Remarks

Attachment I
S.N. 09/538,354
Version with Markings to Show Changes Made

FIG. 2A

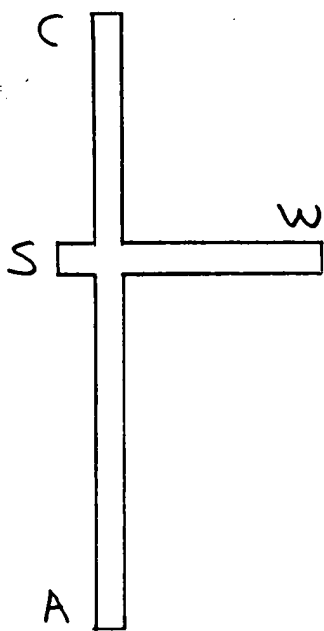
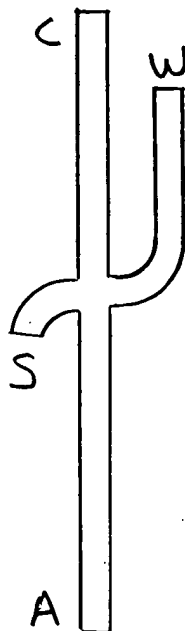
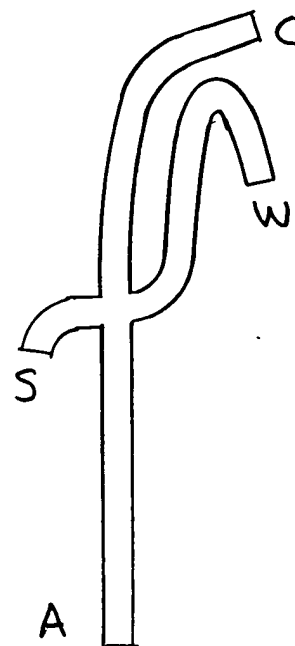
While the Office Action indicates that the drawings as filed on March 29, 2000 are accepted, the drawing do not accurately reflect the description as set forth in the specification. Thus, proposed drawing changes are submitted for approval of Figures 2A, 2B, 2C and Figure 3, with the proposed changes shown in red ink on the enclosed photocopies. Upon approval, the drawing changes will be incorporated into formal drawings to be submitted upon allowance of the claims.
